# Work Change Proposal Request

Oak Street Lofts  
72 Oak Street  
Portland, ME 04101

ARCHITECT'S PROJECT NUMBER: 07.446

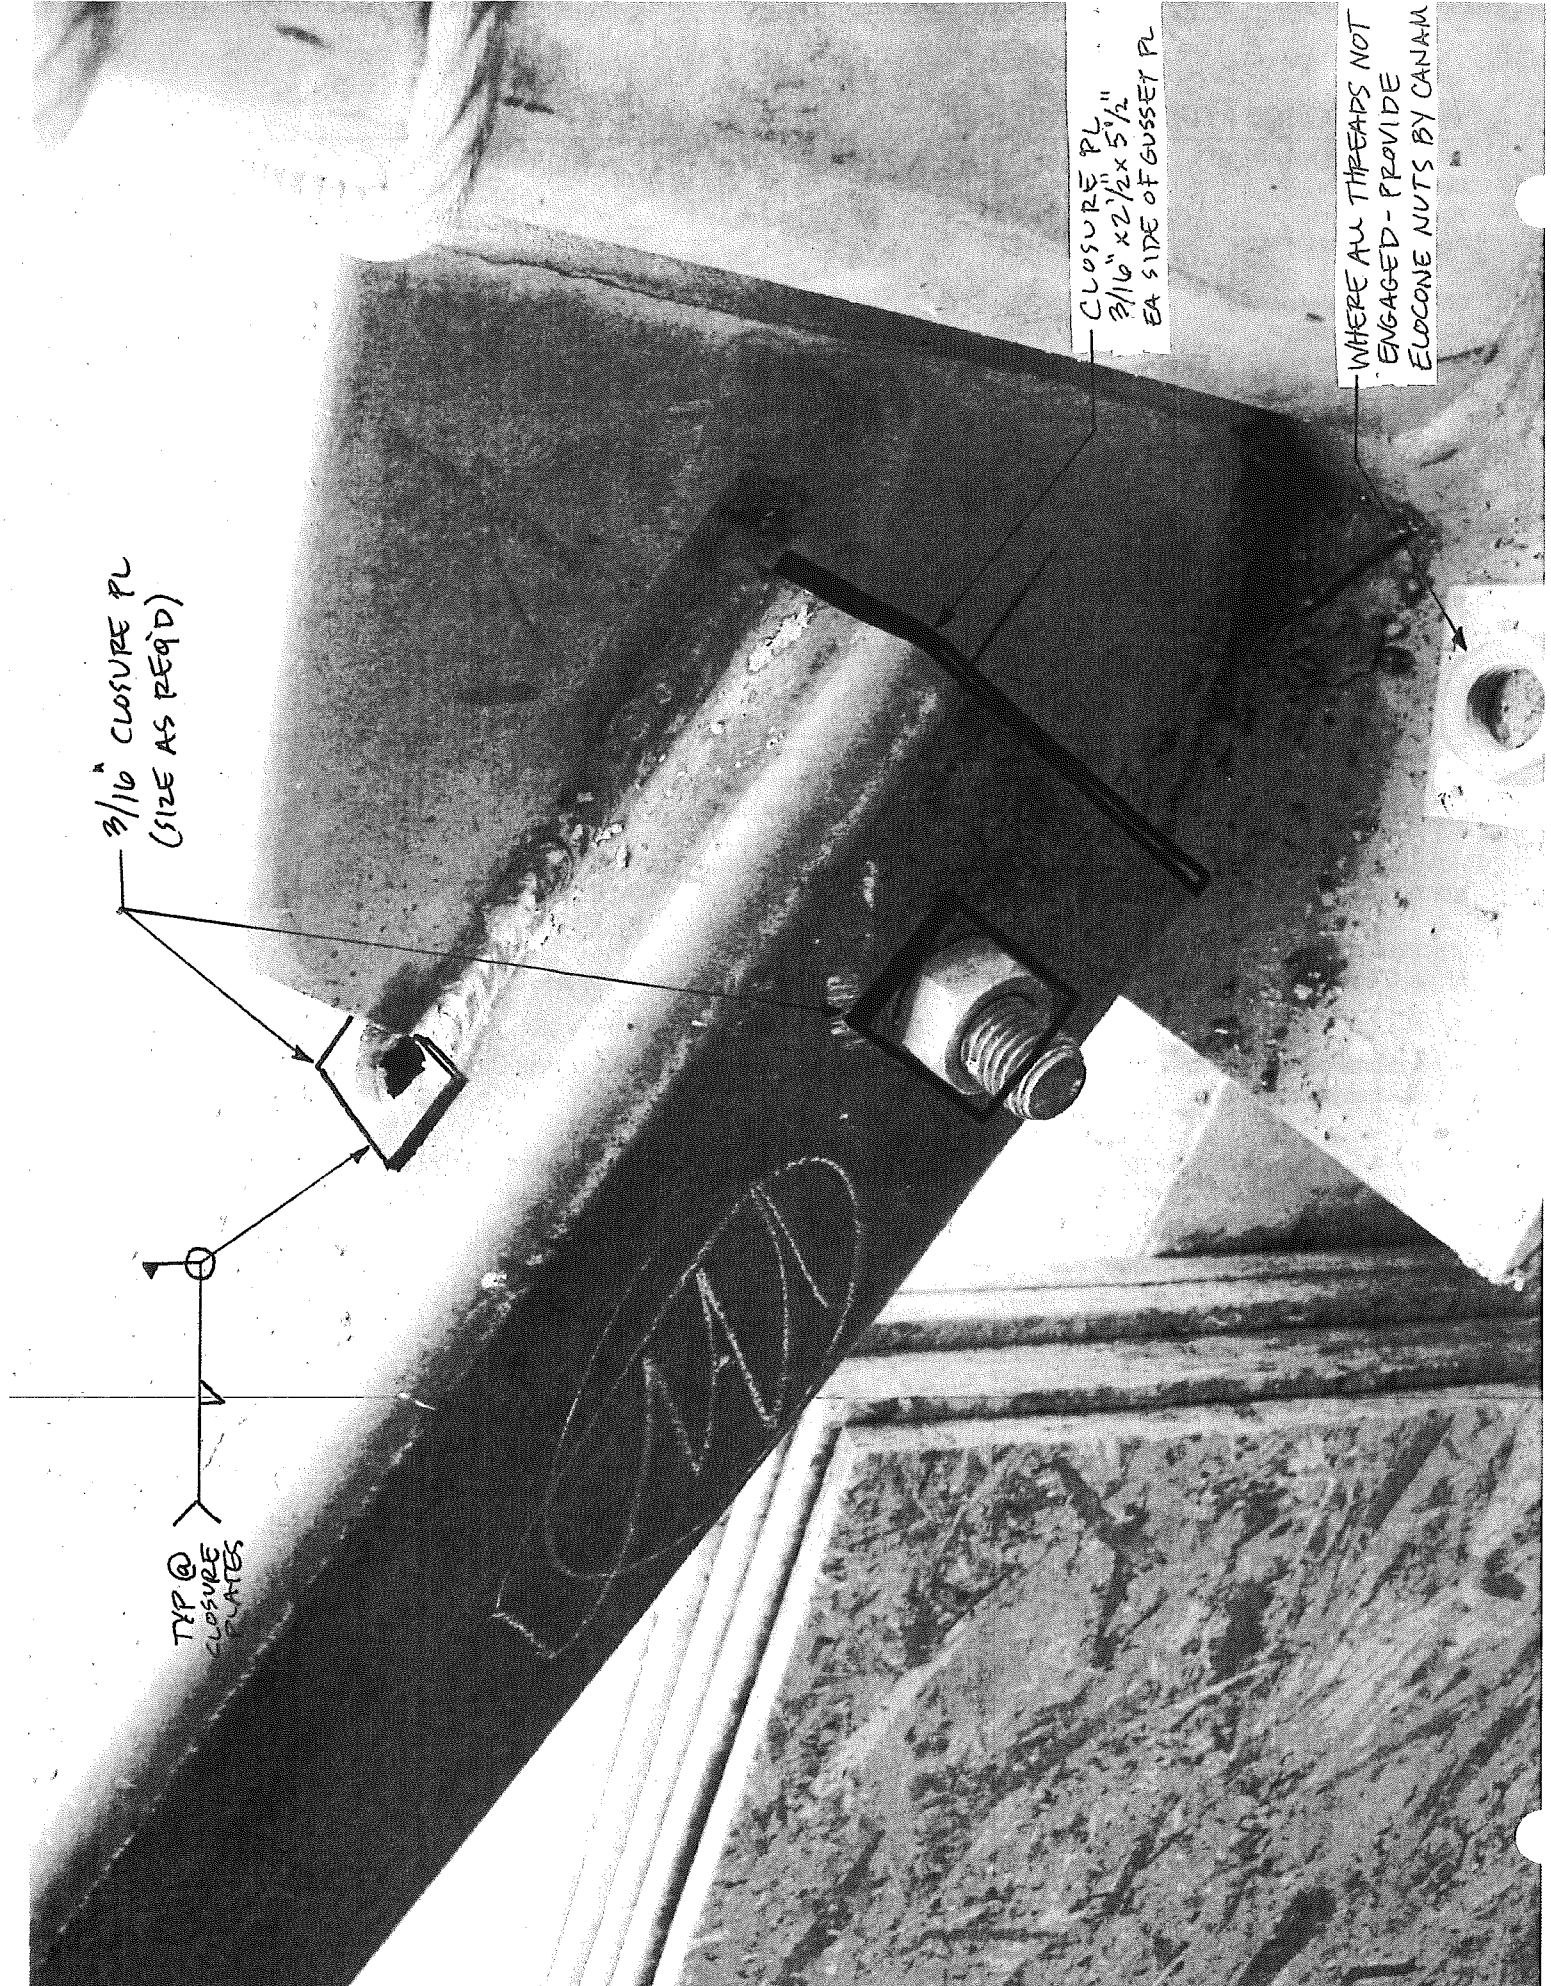
At the A 4/5 diagonal bracing: Close the ends of the brace tubing as per the attached photo sketch.

At all column base plates where anchor nuts are insufficiently engaged to bolt threads, correct attachment as per the attached photo sketch.

At the A 4/5 diagonal bracing: Provide paint finish consisting of Tnemec Series 94 H20 primer (3-3.5 mil dft) w/(2) top coats of 750 OVX (3 mil dft each).

3/16" CLOSURE PL  
(SIZE AS REQ'D)

TYP @  
CLOSURE  
PLATES

CLOSURE PL  
3/16" X 2 1/2" X 5 1/2"  
EA SIDE OF GUSSET PL

WHERE ALL THREADS NOT  
ENGAGED - PROVIDE  
ELOCONE NUTS BY CANAM

**SKA-14**

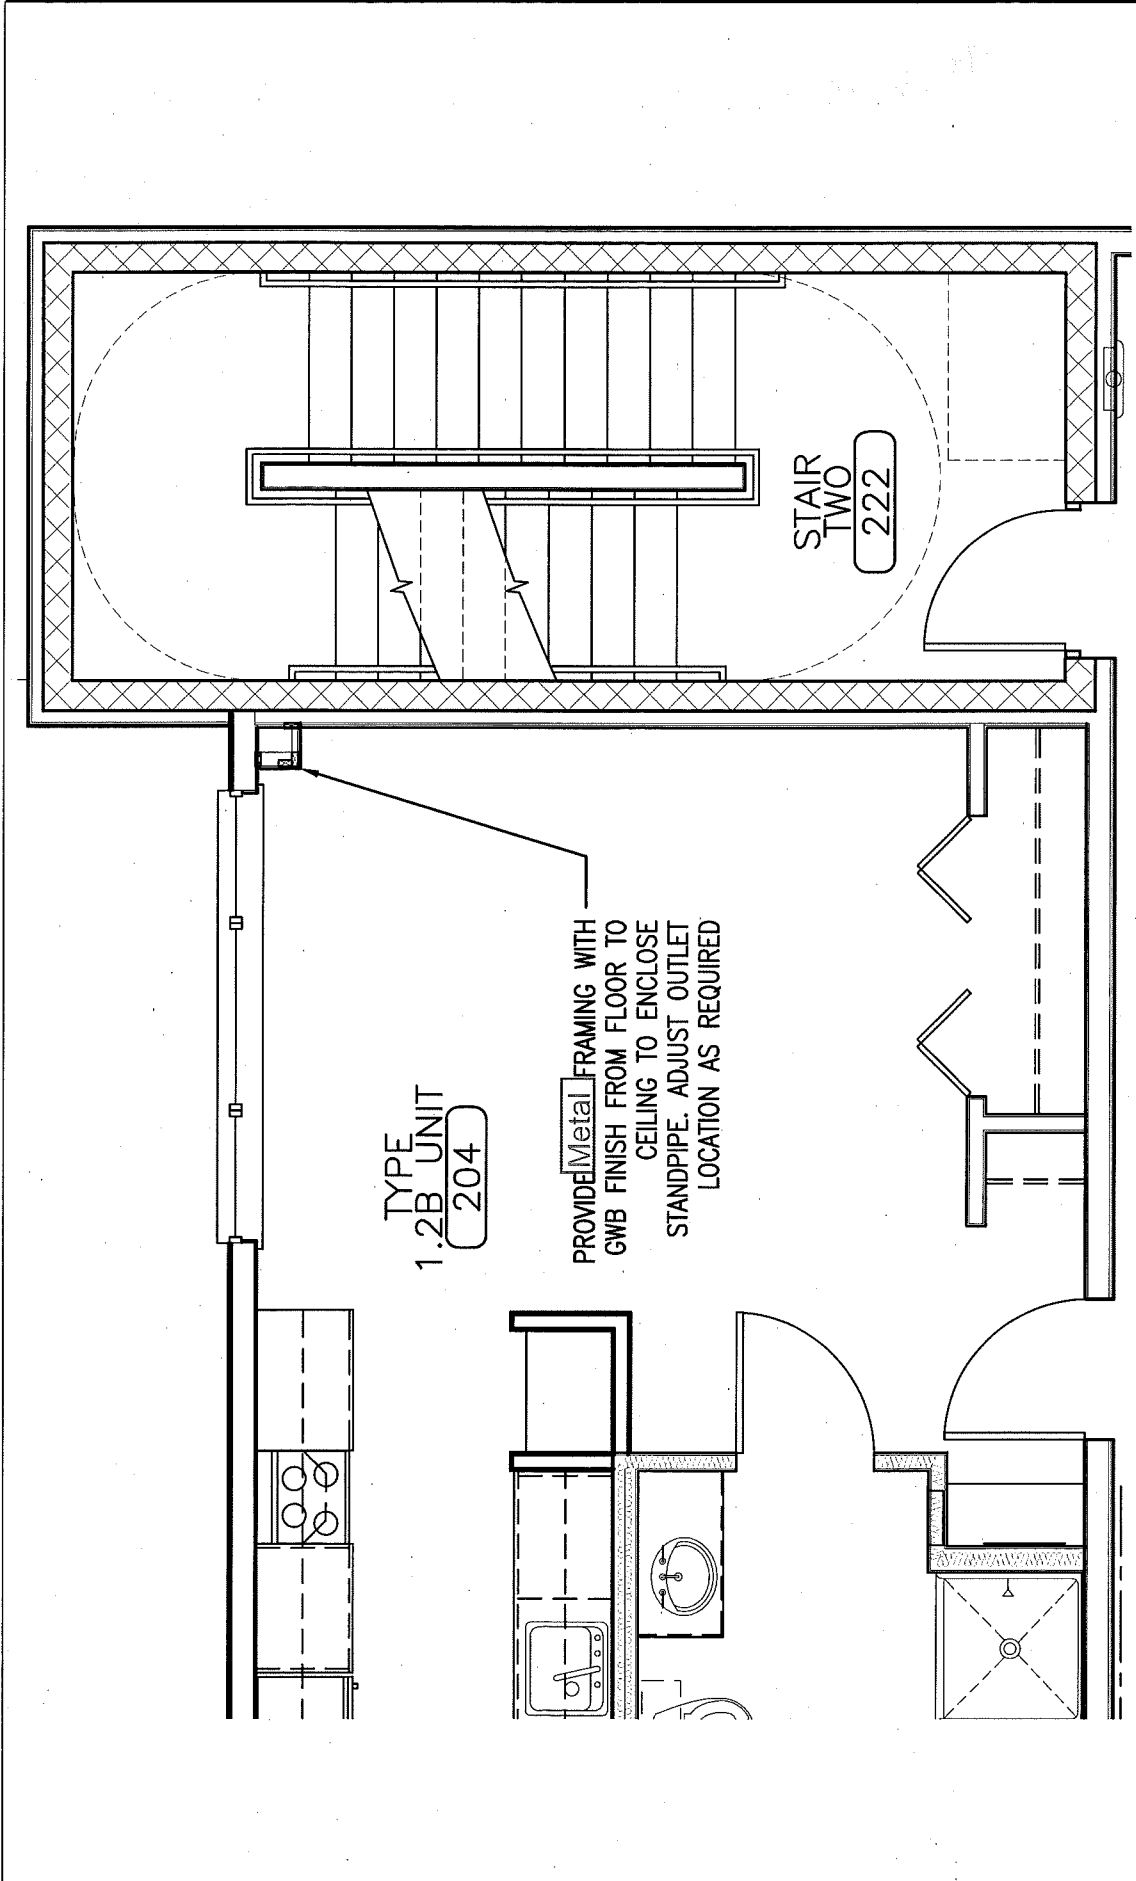
At unit 204 (only) provide wood framed enclosure with Metal finish at sprinkler standpipe as per the attached SKA-14. Adjust electrical outlet location as necessary.

SKM-8

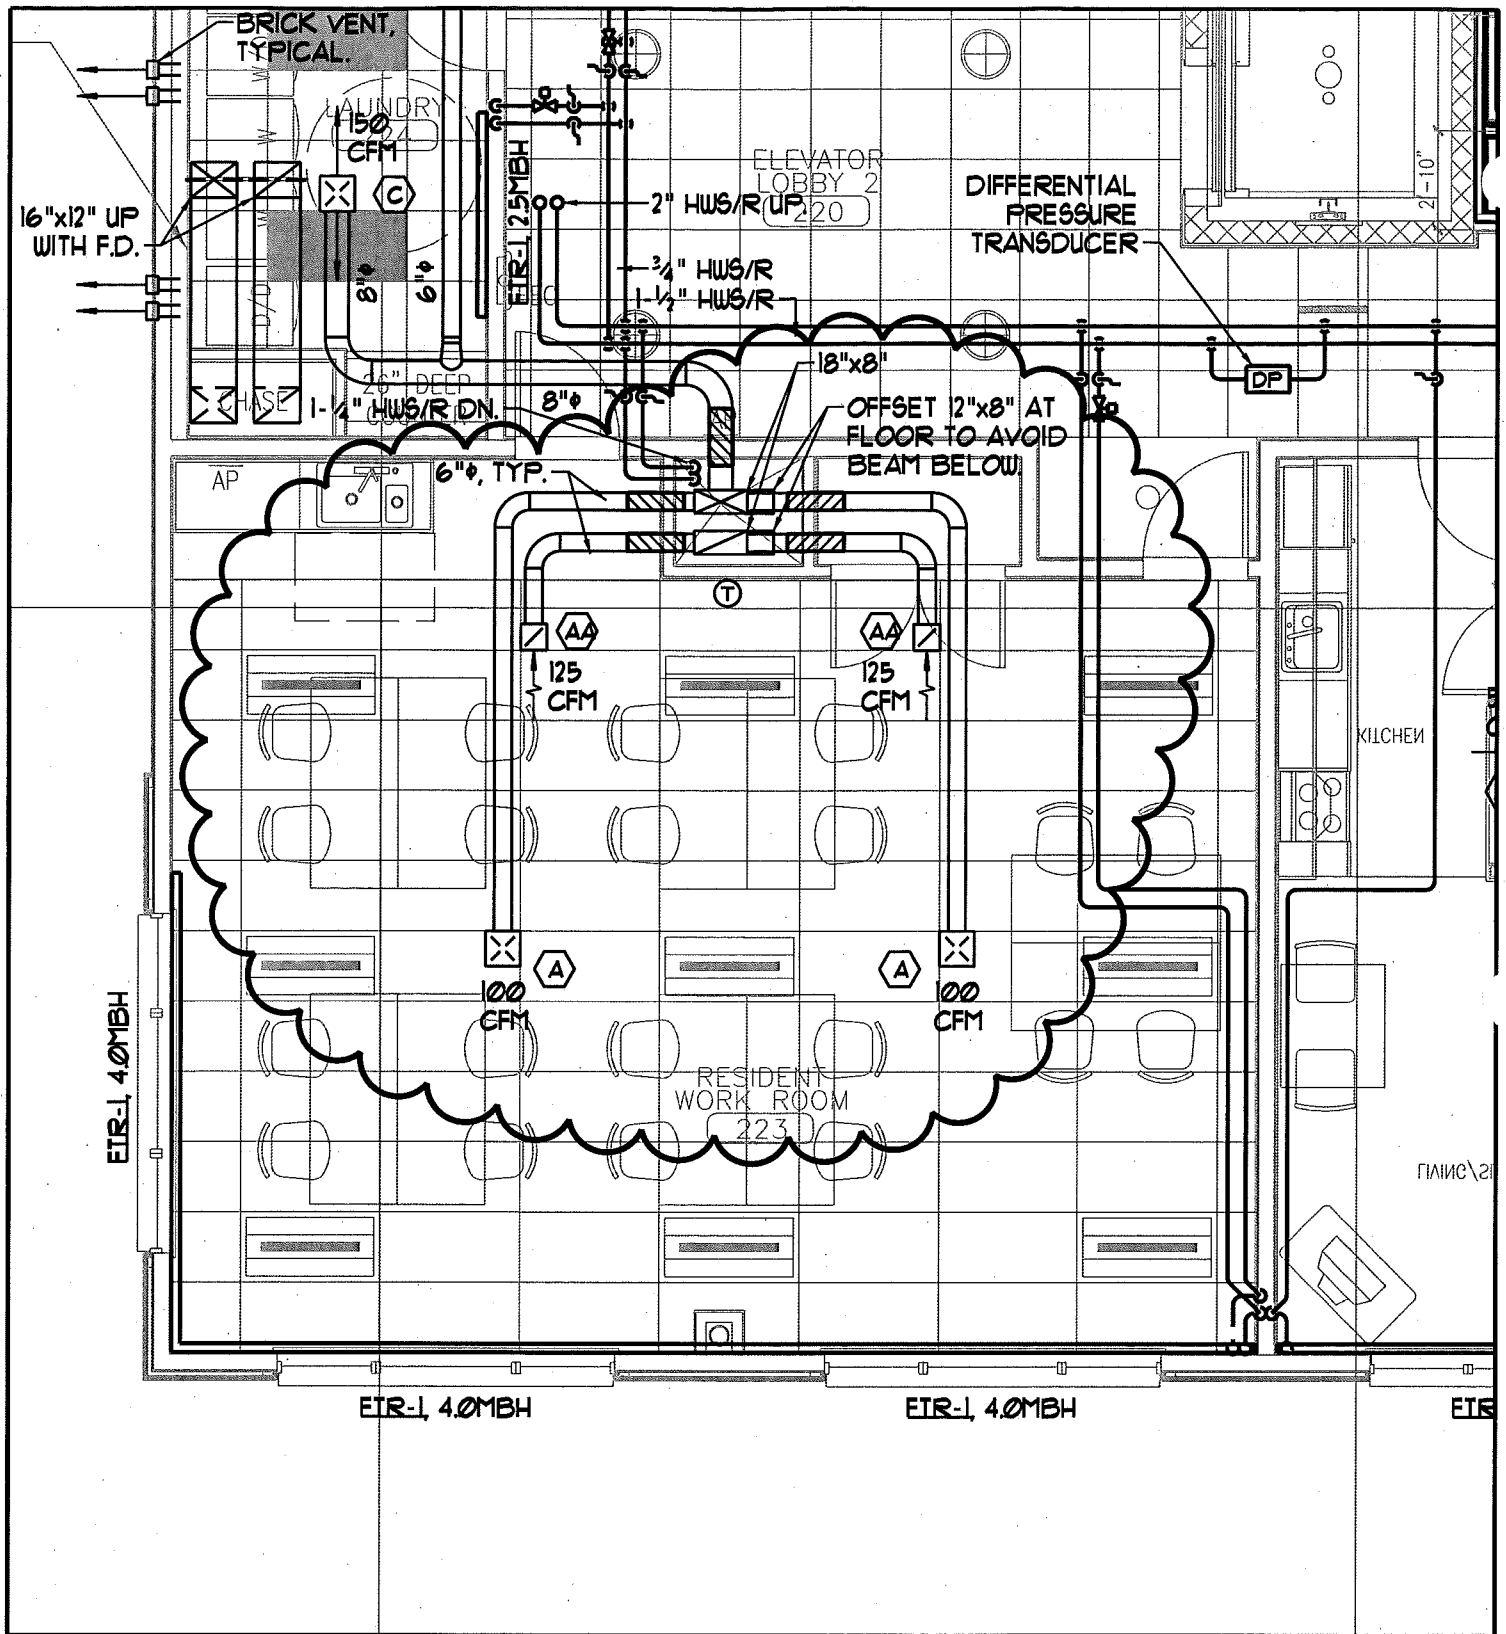
At Resident Work Room 223: in lieu of the design indicated on the October 25, 2010 drawings; provide supply and return ducts above the suspended acoustical ceiling and locate the grills as indicated on the attached SKM-8

Drawing Number:  
**SKA-15**

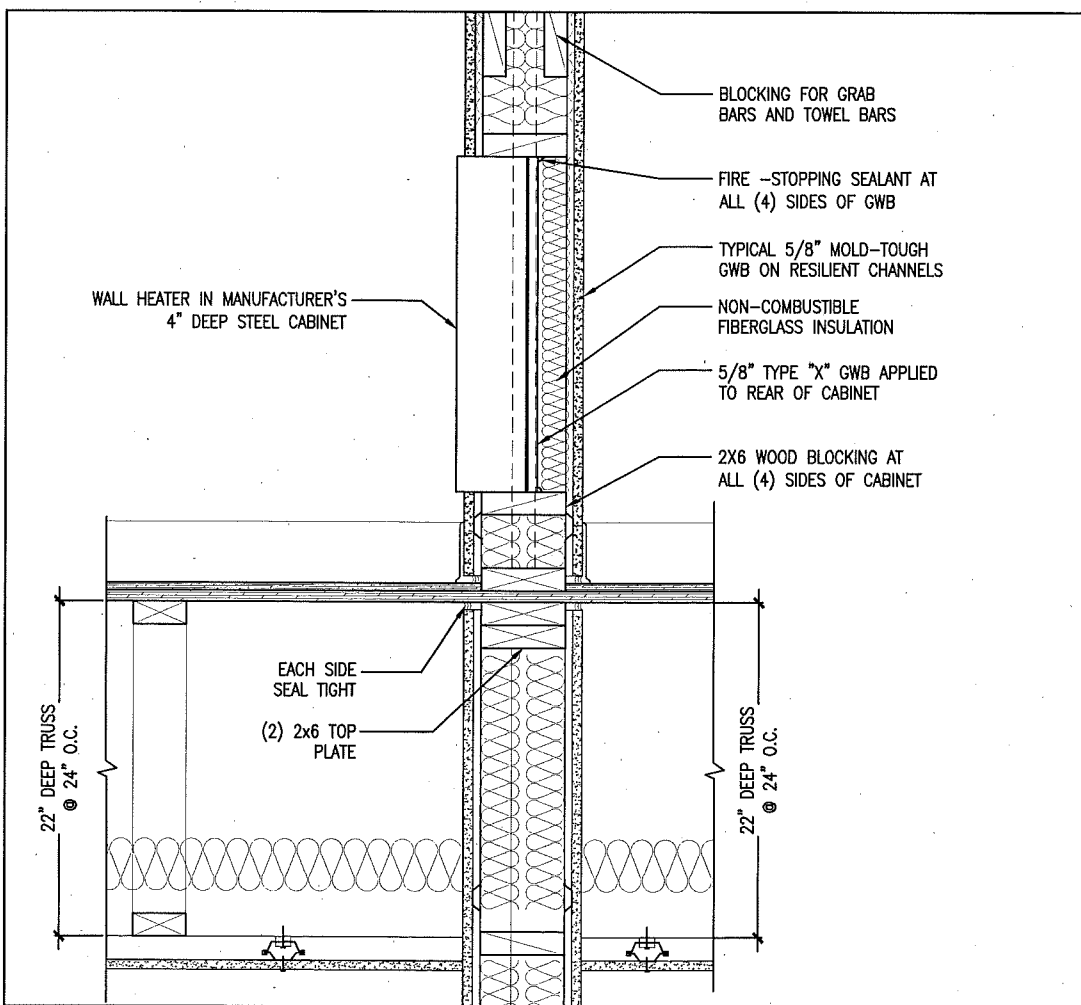
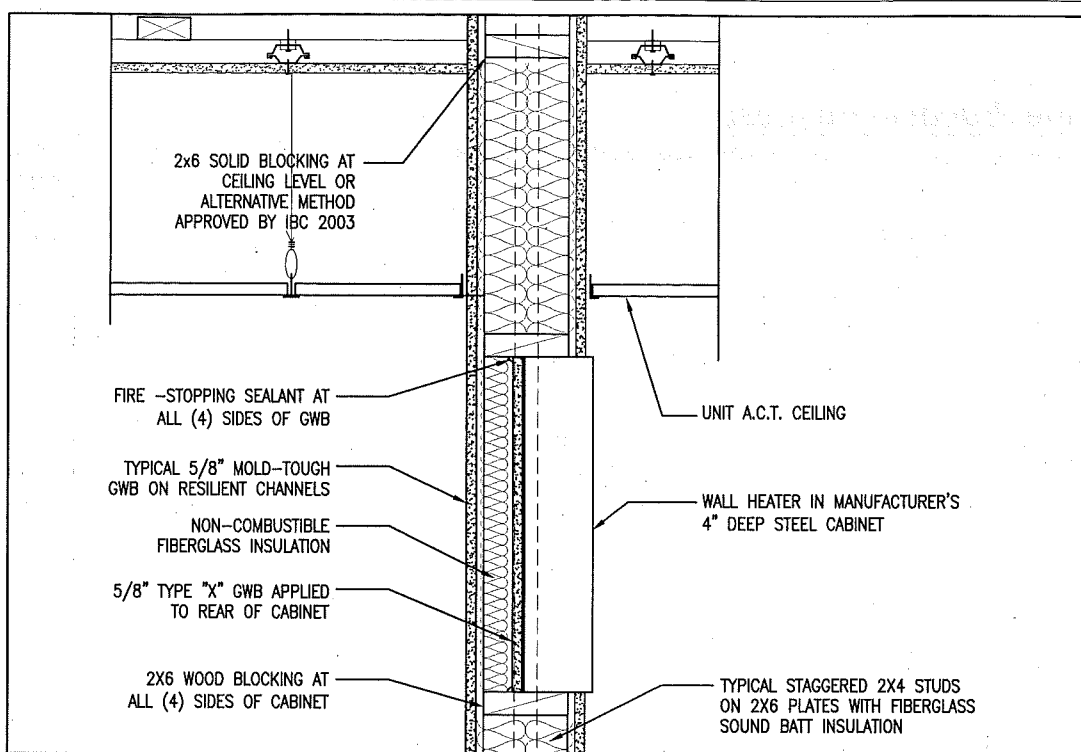
At all unit bathrooms - provide blocking and GWB as indicated by attached SKA-15 to isolate cabinet heaters.

CSK-5

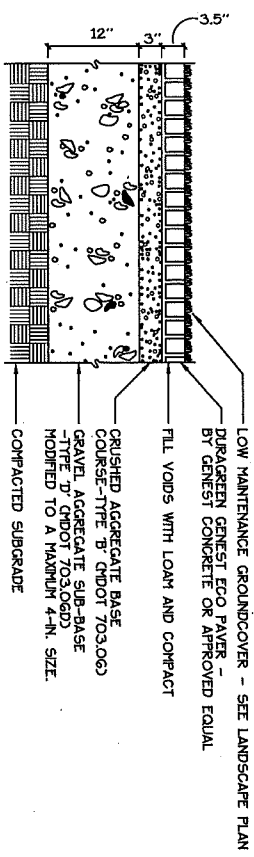
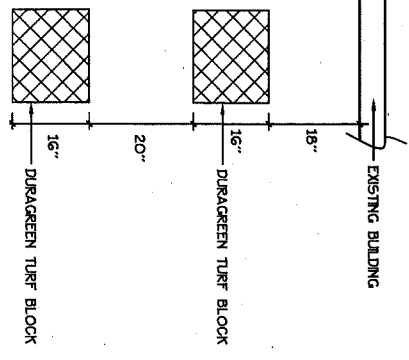
At rear yard, modify fence design as indicated and install stabilized surface pavers as indicated.

NOTE:  
 FENCING ALONG REAR PROPERTY LINE TO BE REMOVED FROM CONSTRUCTION PLAN. FENCING TO EXTEND FROM REAR OF OAK STREET BUILDING TO ABUTTING PACHIOS BUILDING. INSTALL 6' WIDE GATE WITH TWO 3 FOOT GATES, 8 FEET HIGH ON SOUTHERN FENCE AS NOTED. INSTALL STABILIZED SURFACE PAVERS PARALLEL TO PACHIOS BUILDING 1'-8" AWAY FROM BUILDING, 16" WIDE TRACKS, 20" APART.
